EXHIBIT A

Subject: Request for Approval - Work Plan – Use Attainability Analysis – Determine if Naturally Occurring Thermal Conditions Prevent Attainment of Coldwater Aquatic Life Use in the Perennial Reach of Sandia Canyon Assessment Unit (9000.A_047) – Water Quality Segment 20.6.4.126

**Work Plan – Use Attainability Analysis –
Determine if Naturally Occurring Thermal
Conditions Prevent Attainment of Coldwater
Aquatic Life Use in the Perennial Reach of
Sandia Canyon – Water Quality Segment
20.6.4.126**

Use Attainability Analysis Work Plan – Determine if Naturally Occurring Thermal Conditions Prevent the Attainment of Coldwater Aquatic Life Use in the Perennial Reach of Sandia Canyon Assessment Unit (9000.A_047) – Water Quality Segment 20.6.4.126

Figure 2. Proposed stream segment designations.

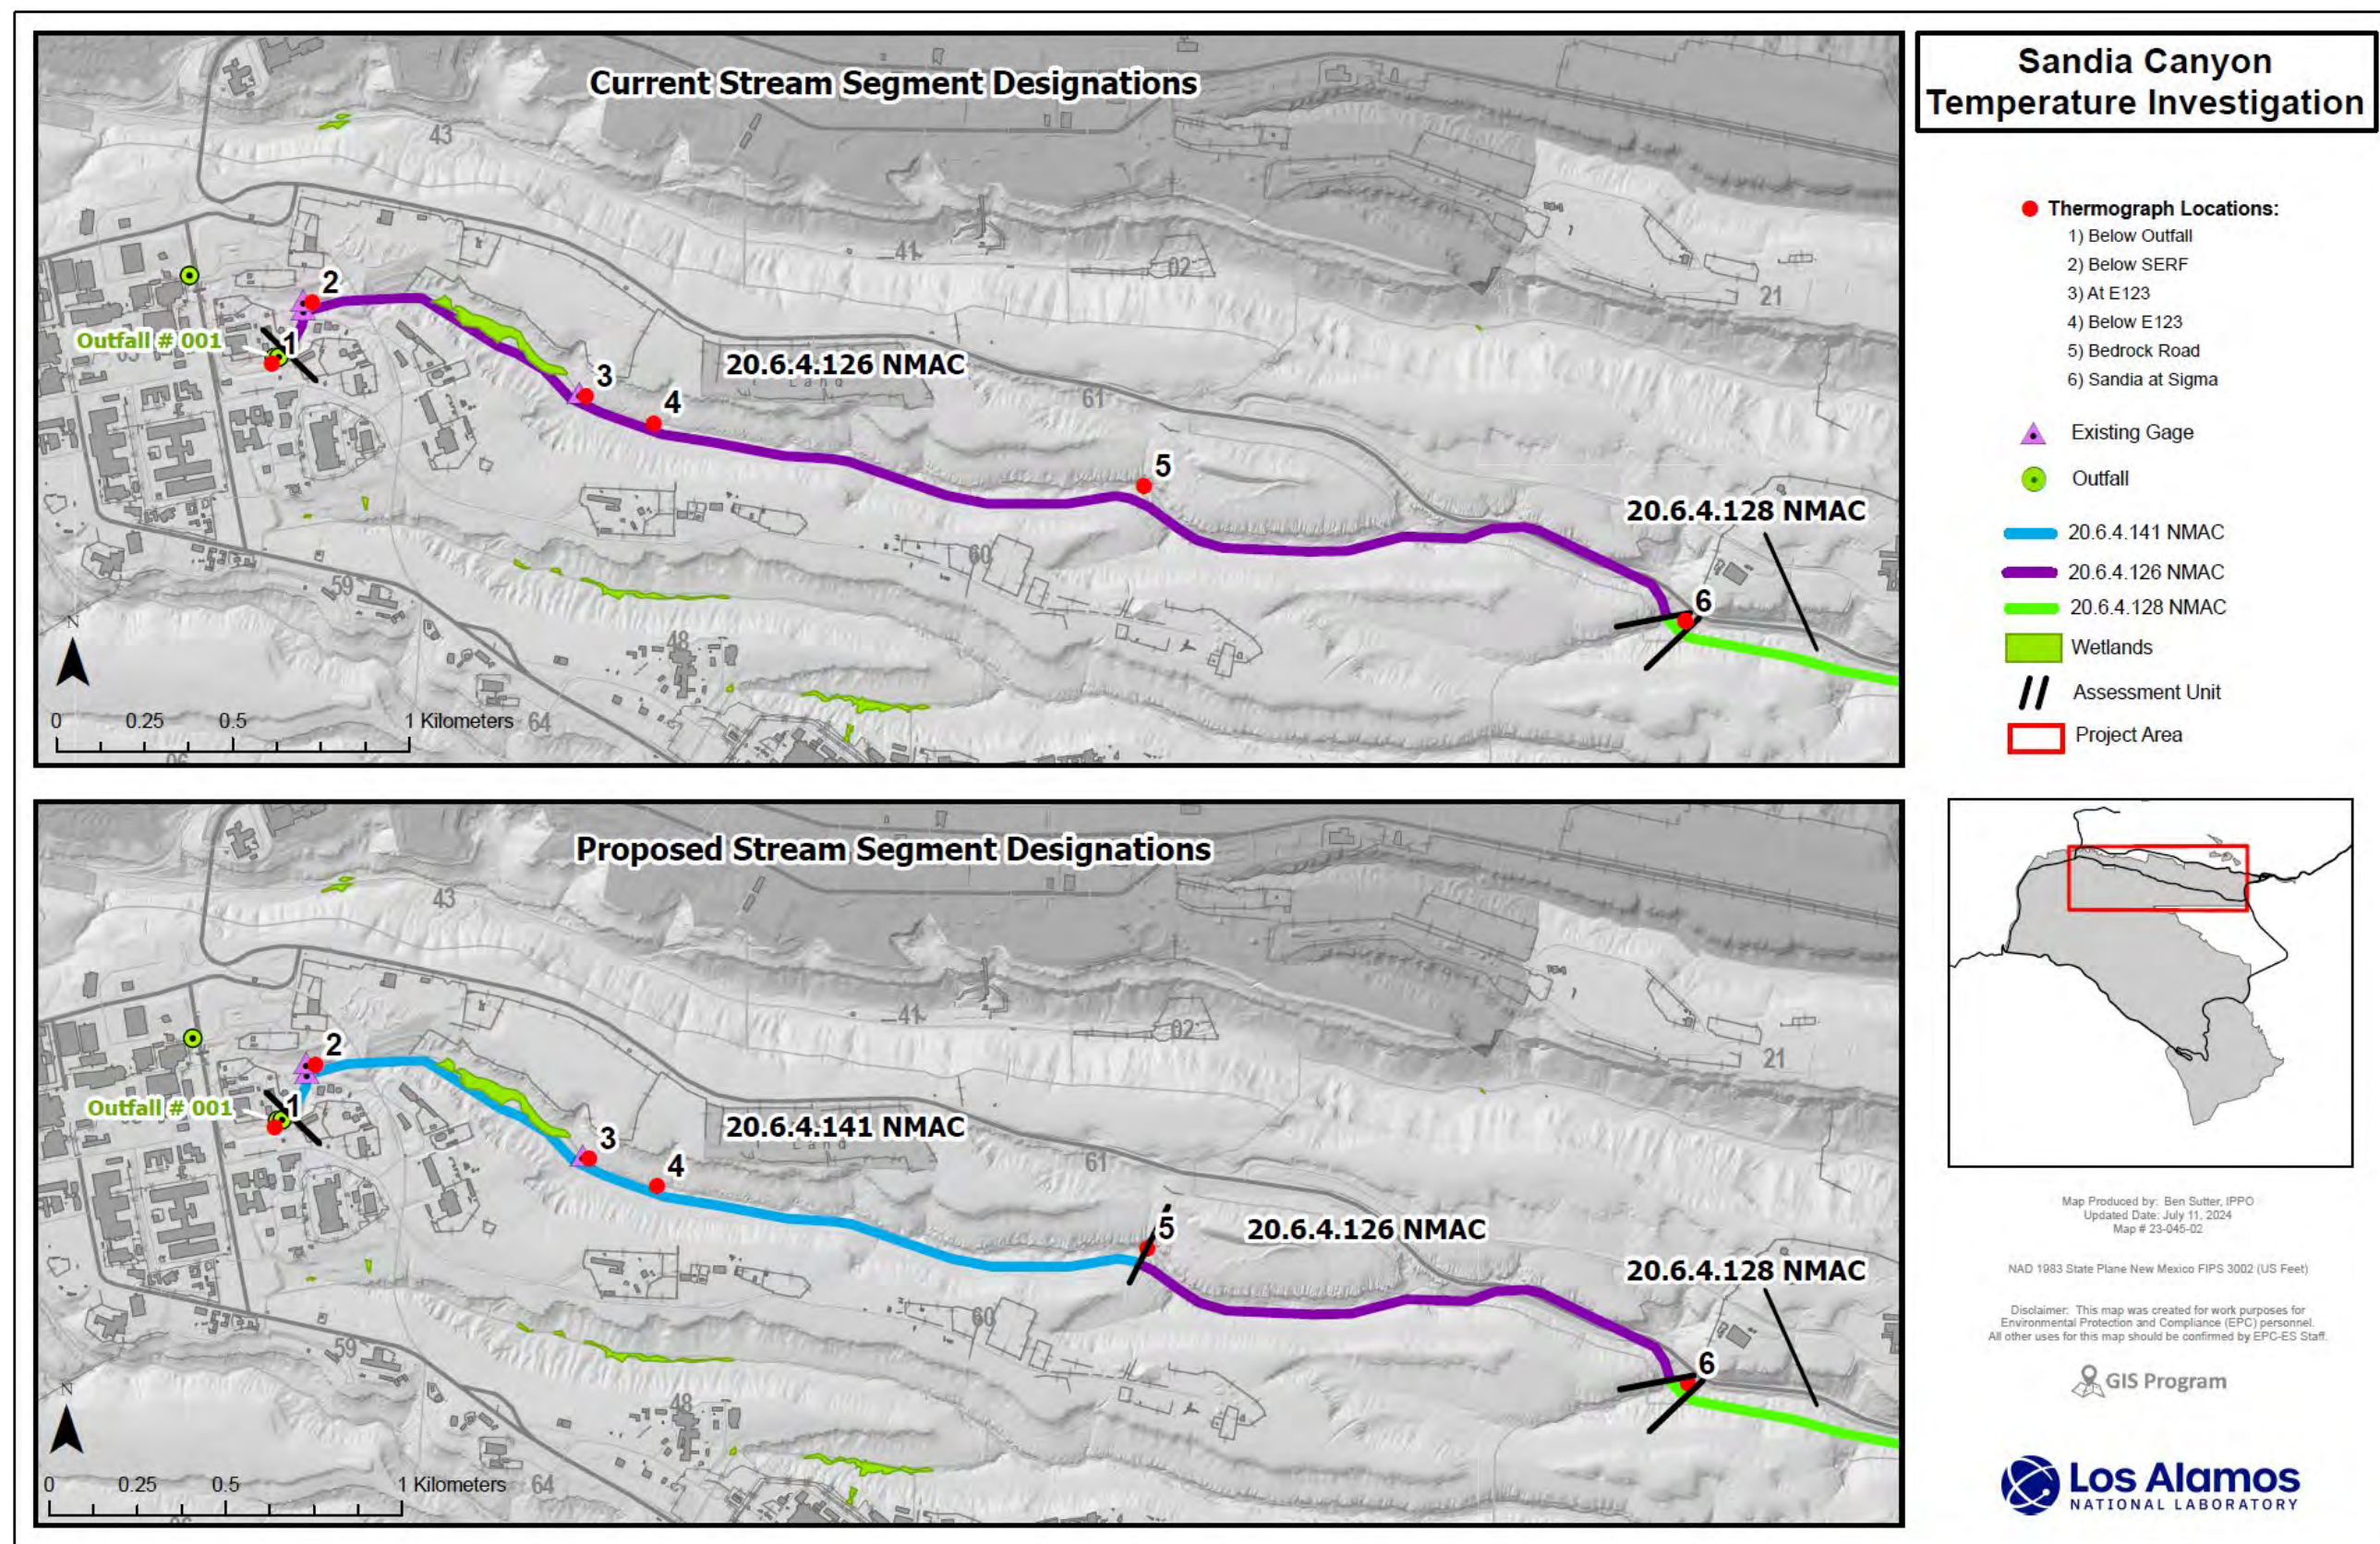
- 2) Figure 1, p. 4 (Attached) – updated to include scale, north arrow, and clarify labeling
- 3) Figure 2, p. 5 (Attached) – updated to include scale, north arrow, and clarify labeling
